Grandview Reserve Phase 1 Traffic Impact Analysis (LSC #S214240) August 12, 2021

LSC Responses to TIS Redline Comments

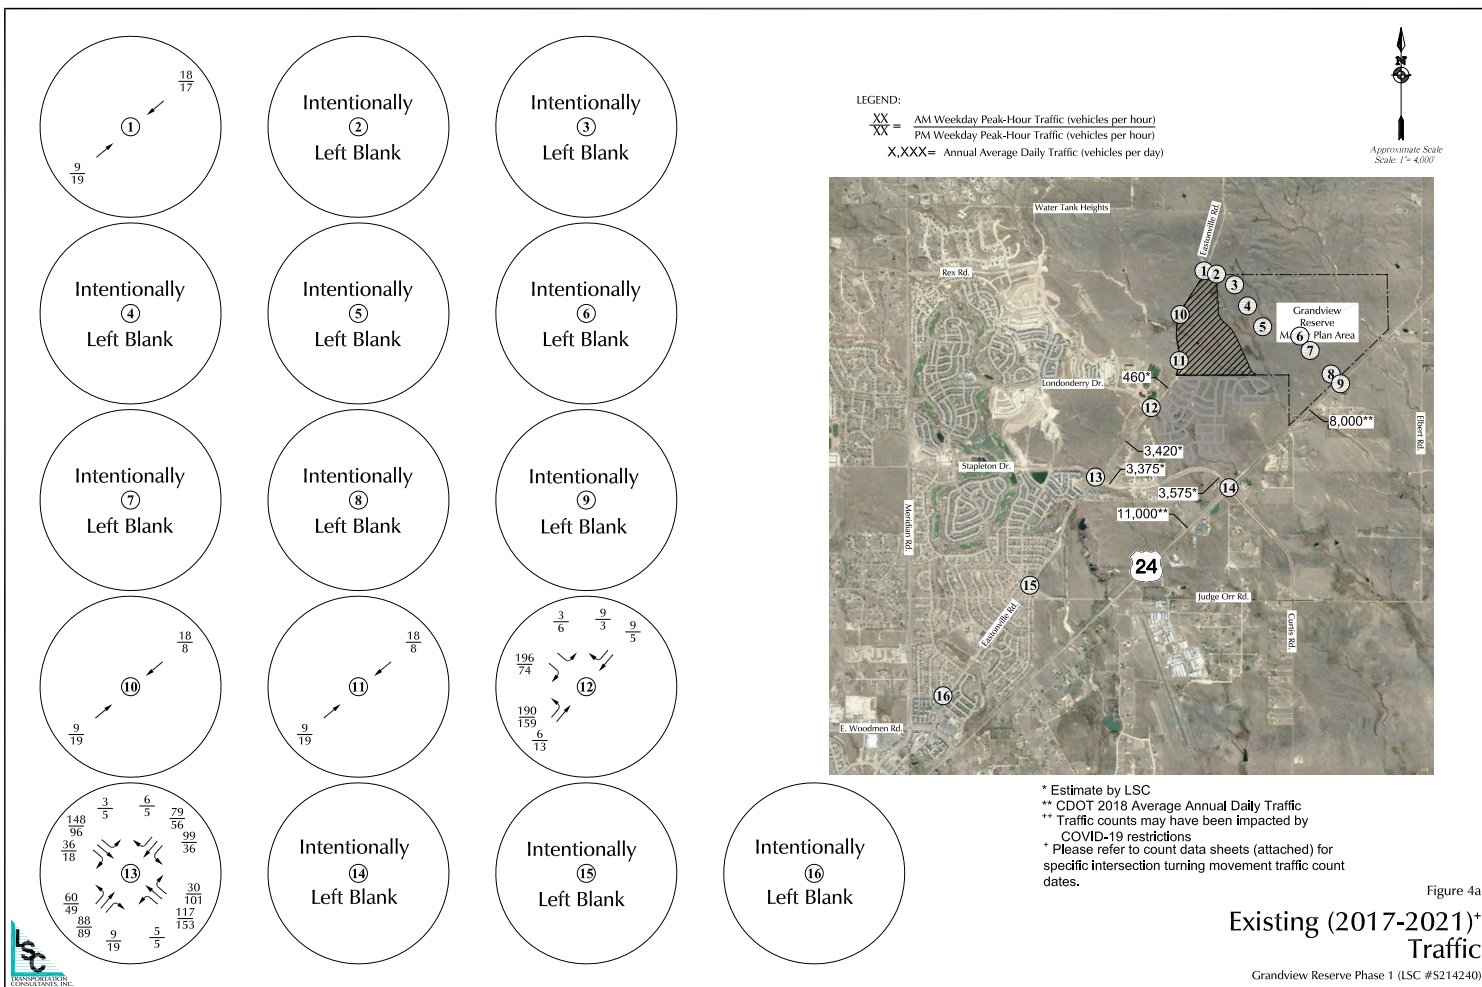
650' (minimum) will be acceptable

This needs to be >700'

Author: kdferrin Subject: Sticky Note Date: 12/9/2021 1:26:54 PM
LSC Response: Revised as Requested

Author: kdferrin Subject: Sticky Note Date: 12/9/2021 1:27:24 PM
LSC Response: Revised as requested

Figure 6a
 Year 2041
 Background Traffic
 Grandview Reserve Phase 1 (LSC #S214240)

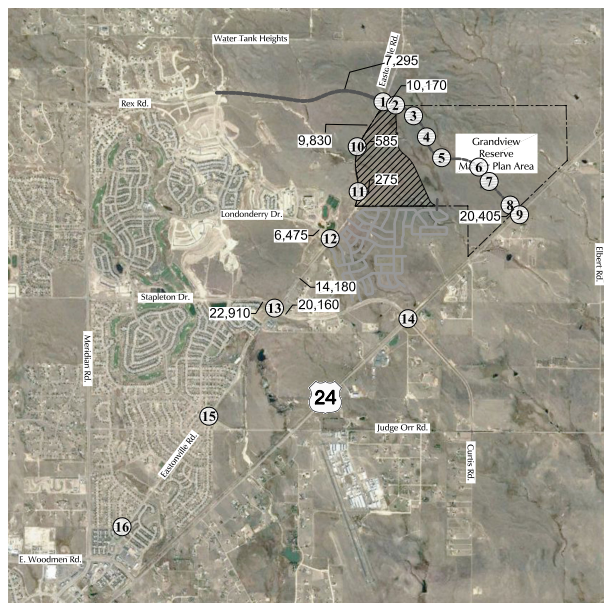
1 Why are these so different than the SKP TIS?

why are these so different than the SKP TIS?

LSC Response: The background traffic in the SKP TIS did not include any Grandview Sketch Plan trips (all those trips were "site traffic" in that report for the entire development). The 2040 Background volumes in this report for the Phase 1 portion include projected traffic from future Grandview Reserve filings. Only phase 1 traffic is "site traffic."

Figure 6c

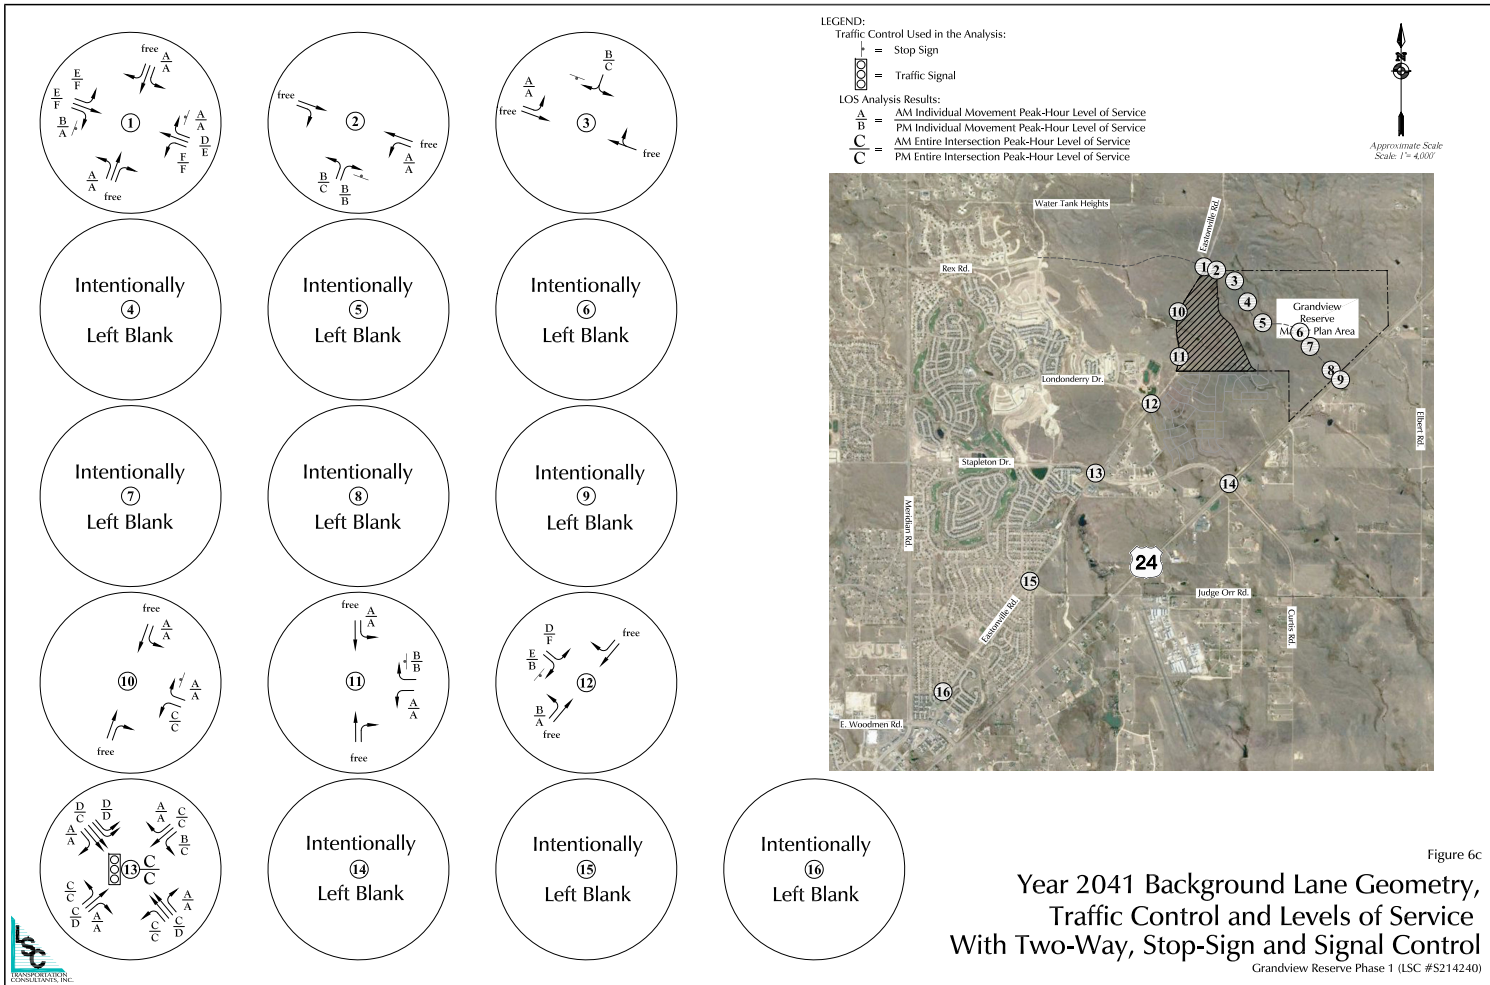
1 Add the roundabout LOS sheet

[Add the roundabout LOS sheet](#)

Author: kdferrin Subject: Sticky Note Date: 12/9/2021 1:32:56 PM
LSC Response: Added as requested

Figure 7

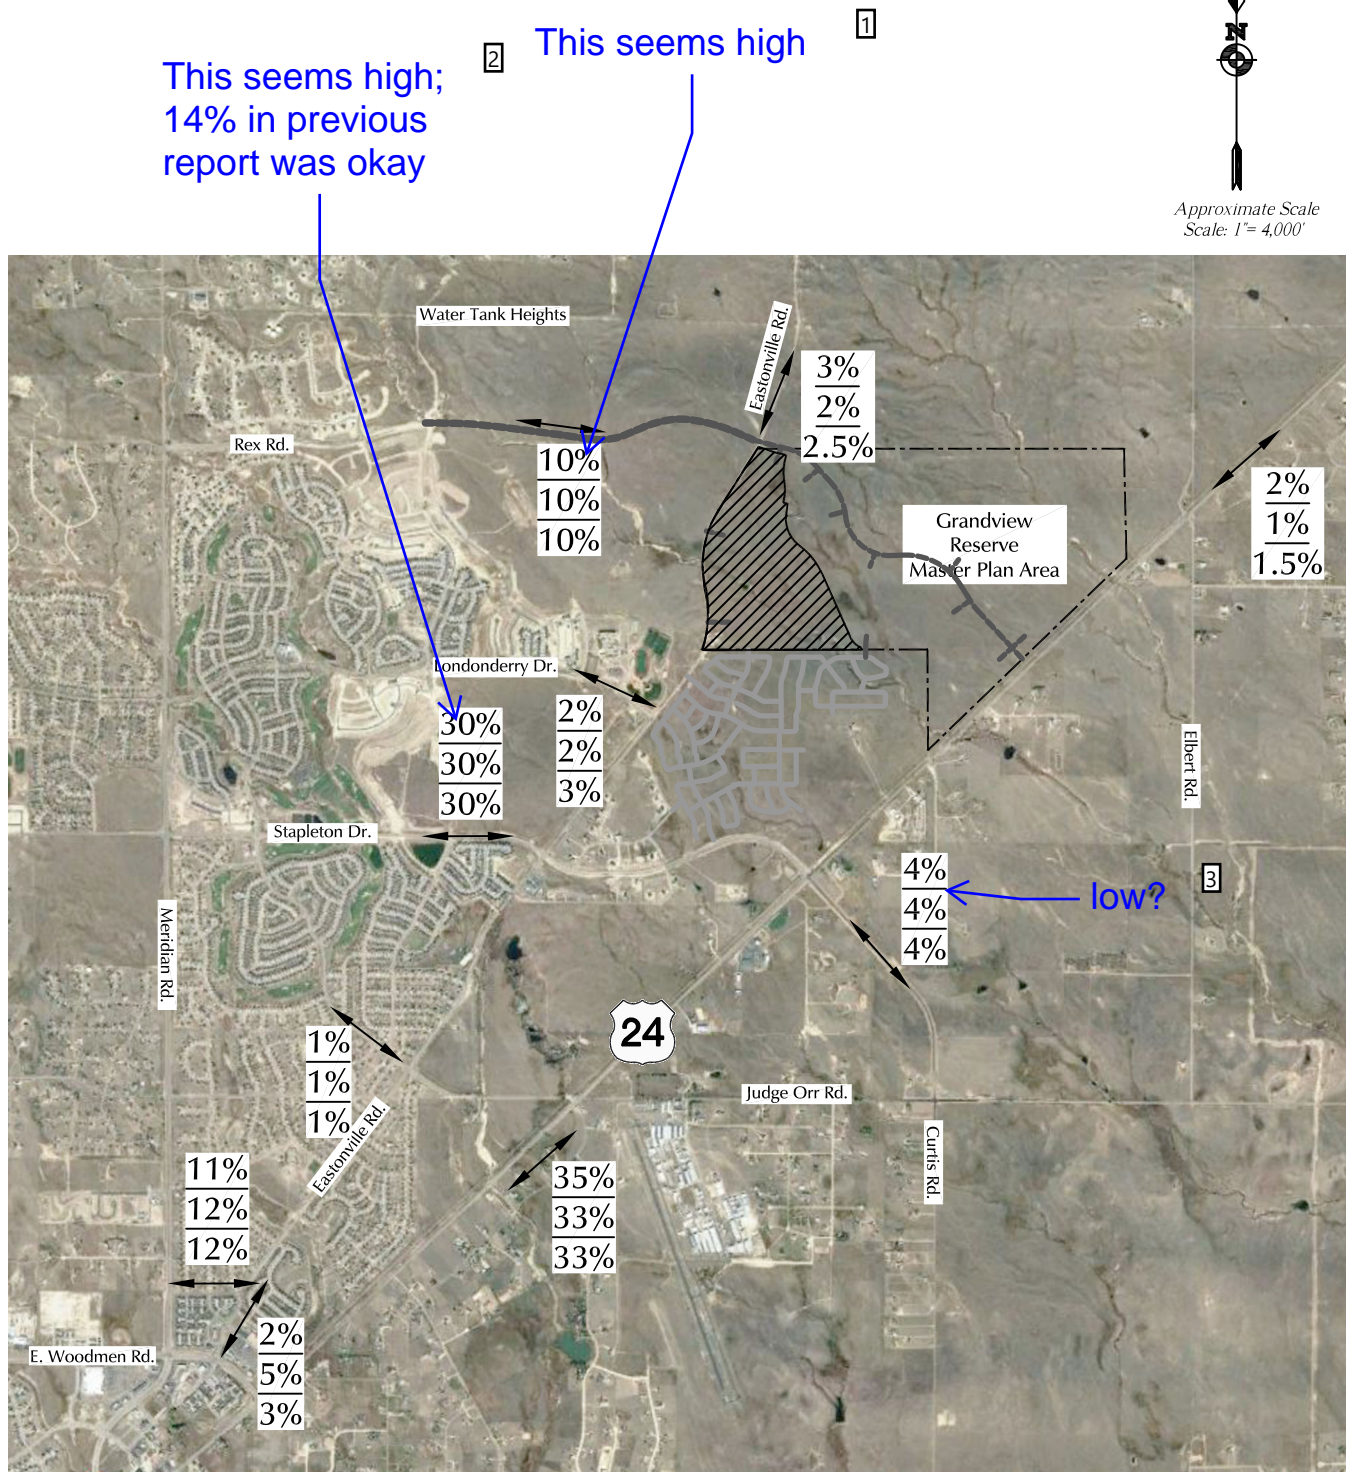
This seems high

This seems high; 14% in previous report was okay

low?

Author: kdferrin Subject: Sticky Note Date: 12/10/2021 2:32:39 PM
LSC Response: The directional distribution estimates have been revised.

Author: kdferrin Subject: Sticky Note Date: 12/10/2021 2:32:54 PM
LSC Response: The directional distribution estimates have been revised.

Author: kdferrin Subject: Sticky Note Date: 12/10/2021 2:33:00 PM
LSC Response: The directional distribution estimates have been revised.

Figure 8

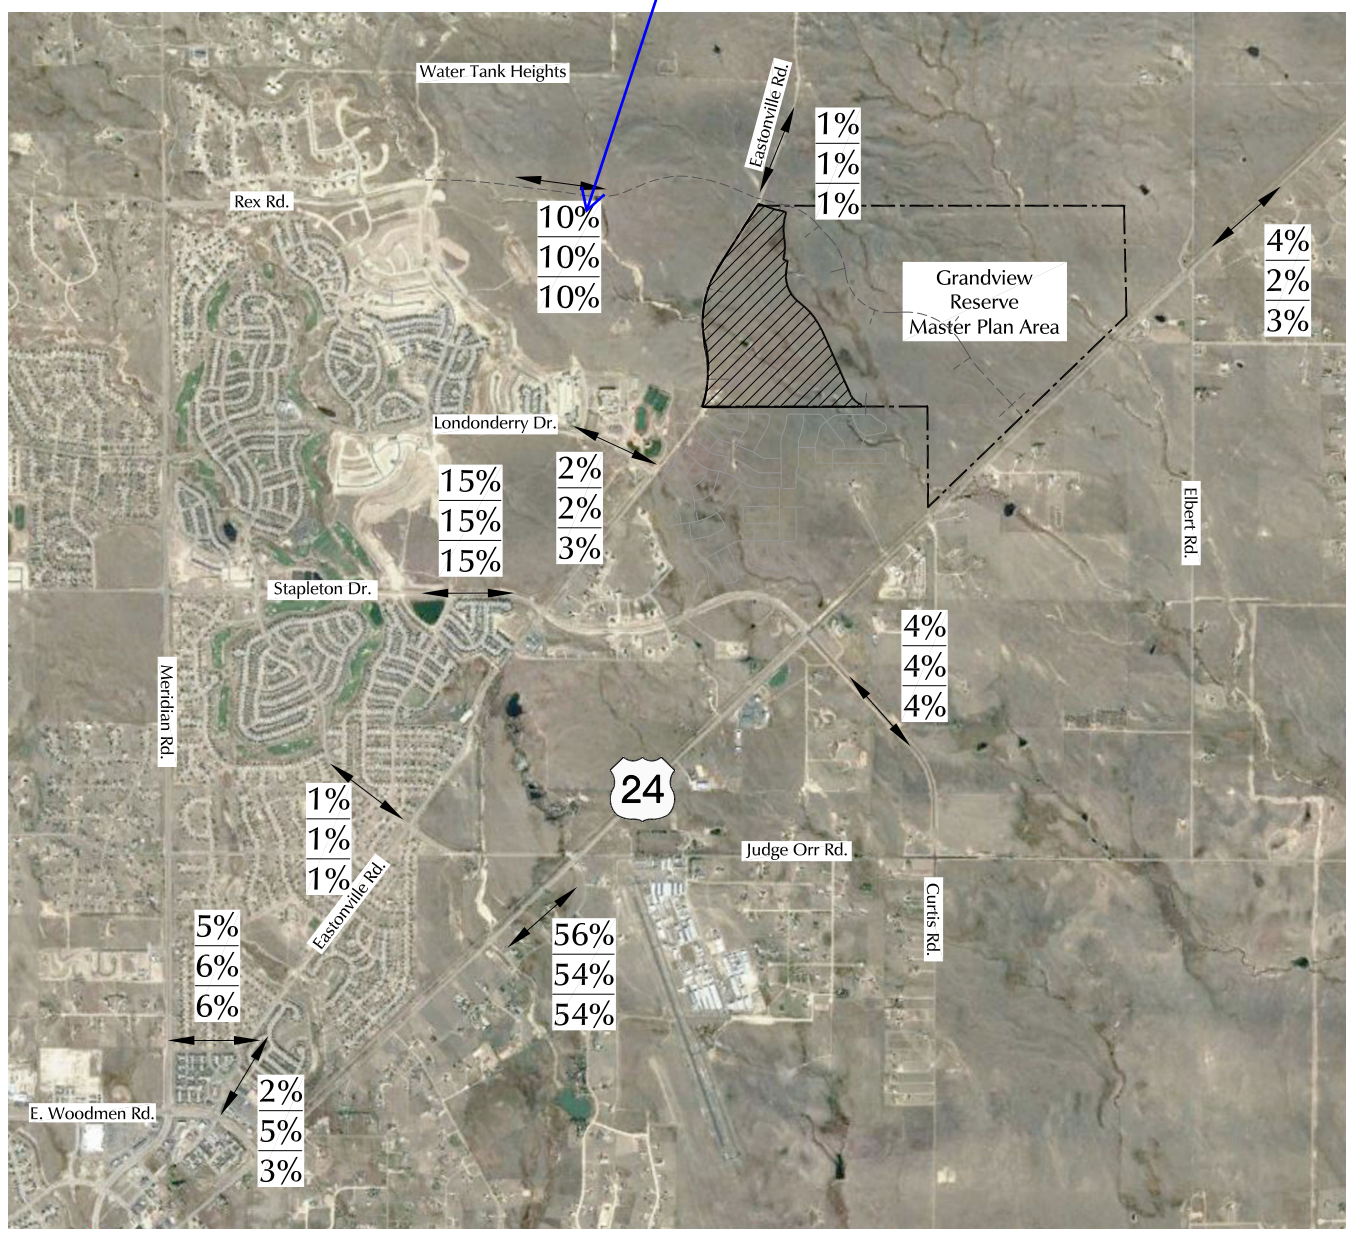
This seems high 1

This seems high

Author: kdferrin Subject: Sticky Note Date: 12/10/2021 2:33:24 PM
LSC Response: The directional distribution estimates have been revised.

Figure 11b
 Year 2026 Total Lane Geometry,
 Traffic Control and Levels of Service
 with Two-Way Stop-Sign Control
 Grandview Reserve Phase 1 (LSC #S214240)

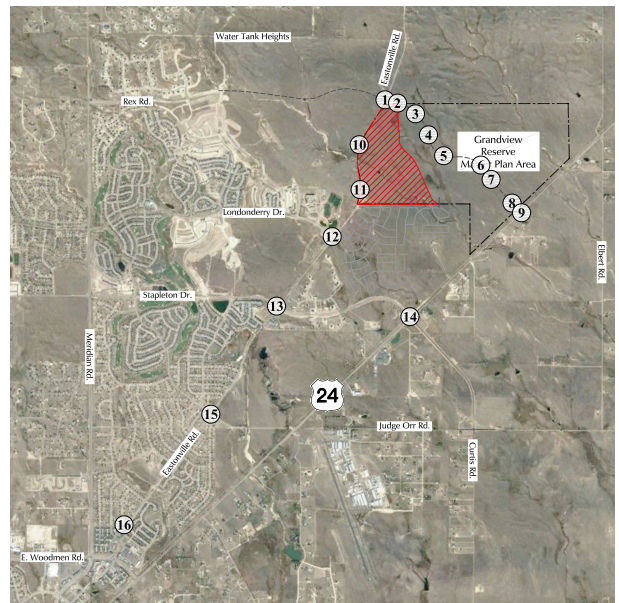
1 include these intersections

[include these intersections](#)

LSC Response: The intersection of US 24/Stapleton has been included in the updated TIS. Rex/US 24 is not planned to be constructed as part of Phase 1.

Figure 12a
 Year 2041
 Total Traffic
 Grandview Reserve Phase 1 (LSC #S214240)

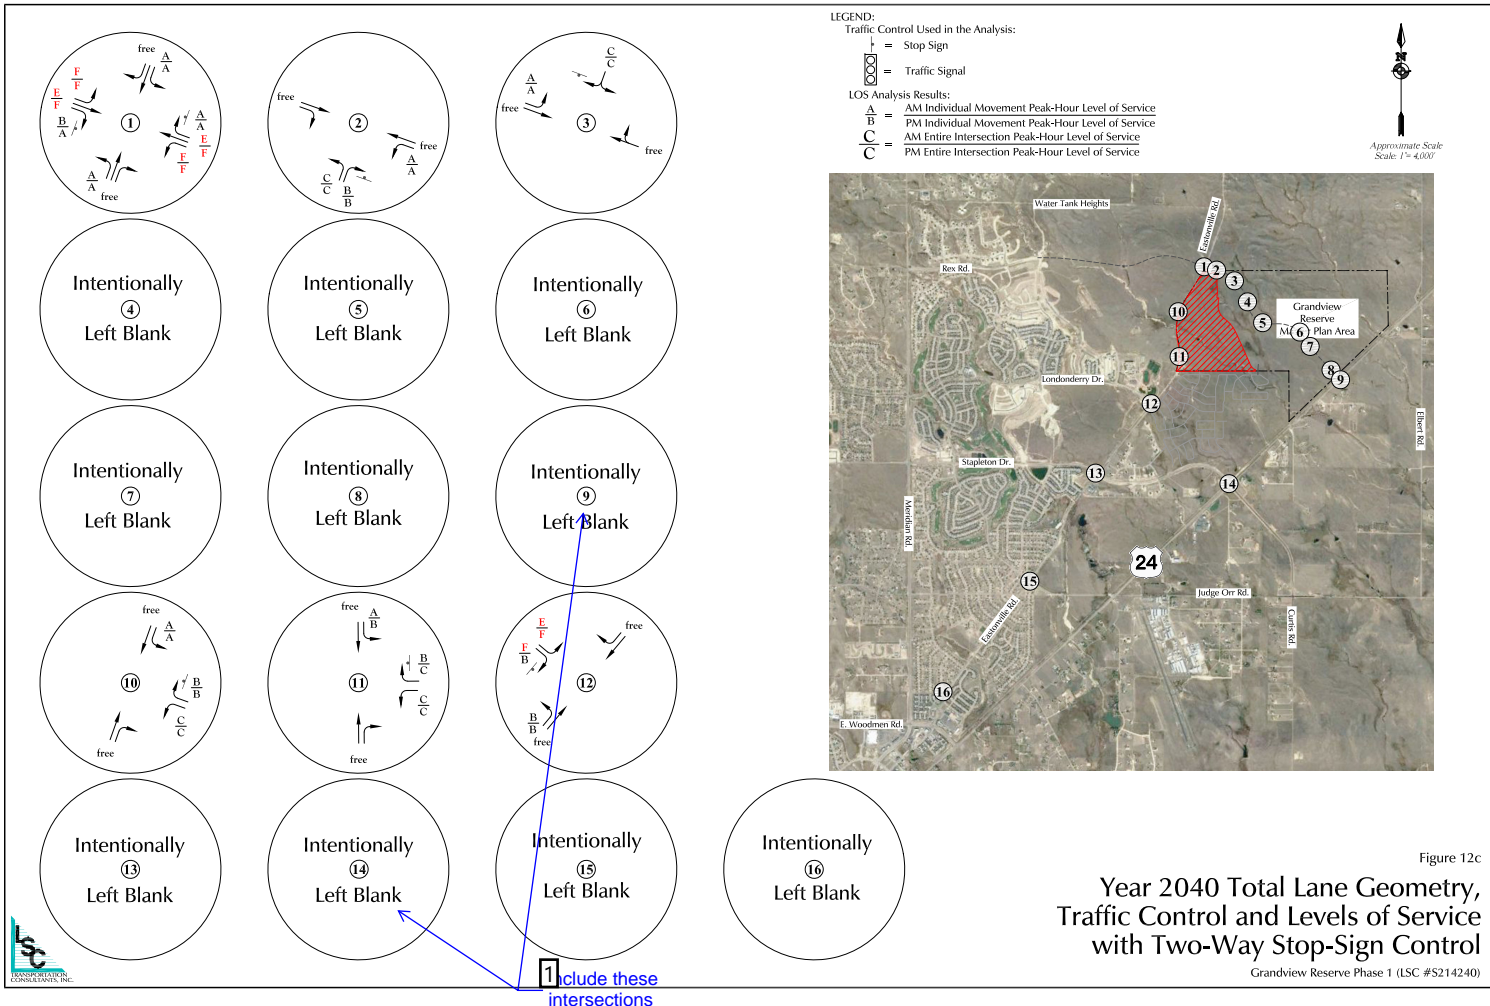
1 include these intersections

[include these intersections](#)

Author: kdferrin Subject: Sticky Note Date: 12/10/2021 2:34:38 PM
LSC Response: The requested analysis has been included in the updated TIS.

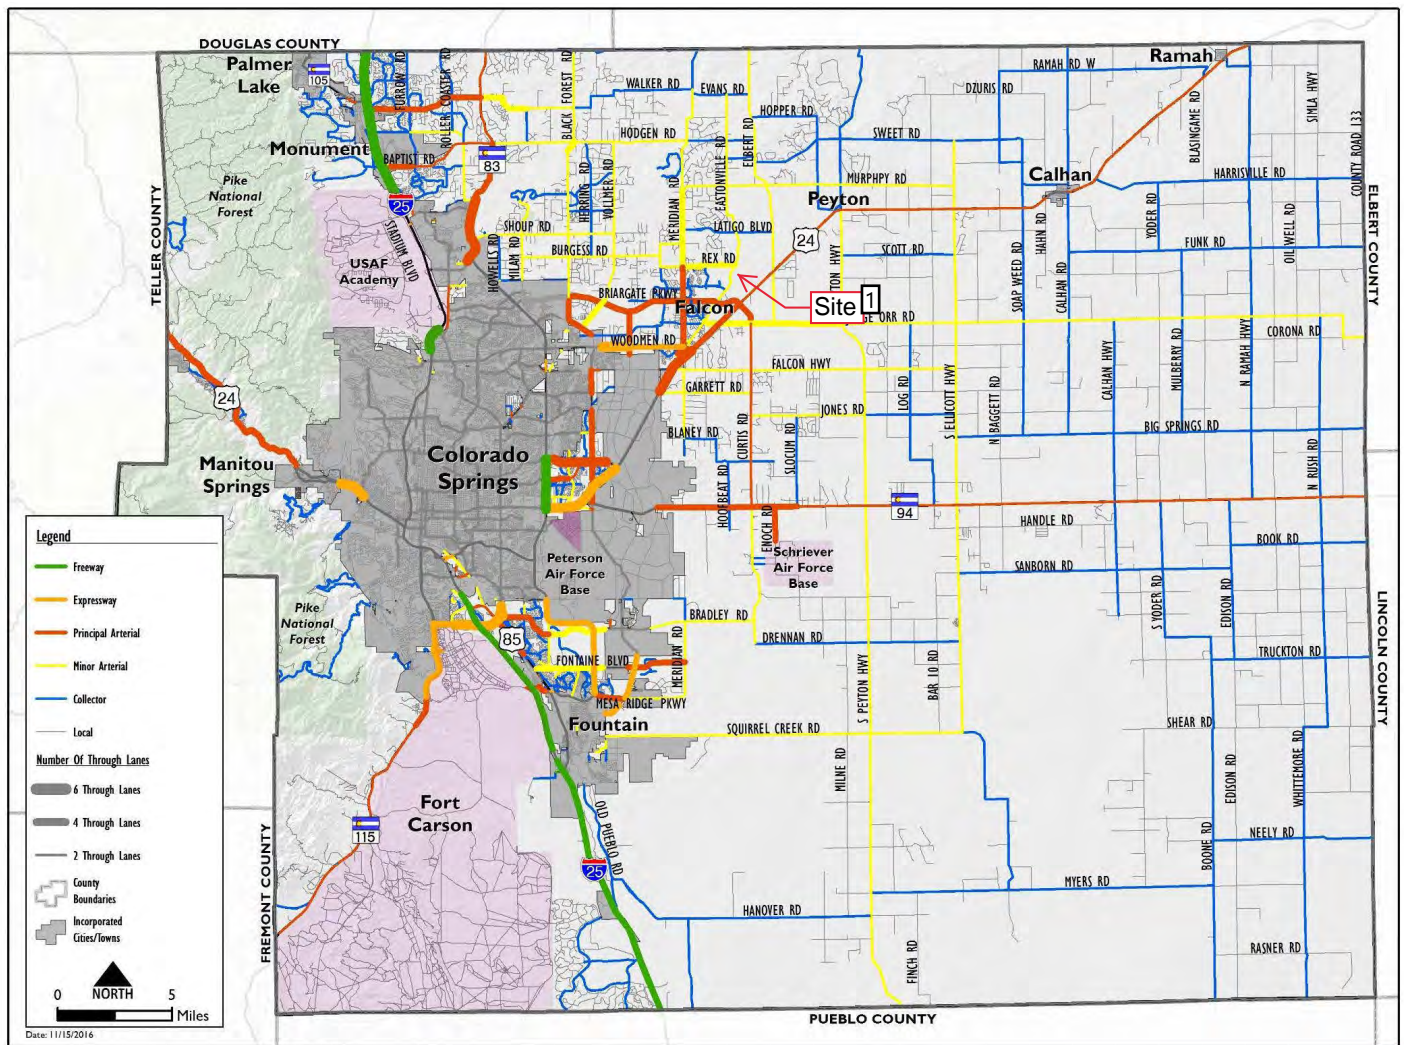
[Account for both \(verify allowable PUD uses\)](#)

[Verify that this will not need to be a collector with the other uses added](#)

LSC Response: The trip generation estimate has been revised to include the latest information on the proposed church located on the northwest parcel and the proposed amenity center on the southeast parcel

LSC Response: The recommended street classifications has been verified in the updated TIS as requested.
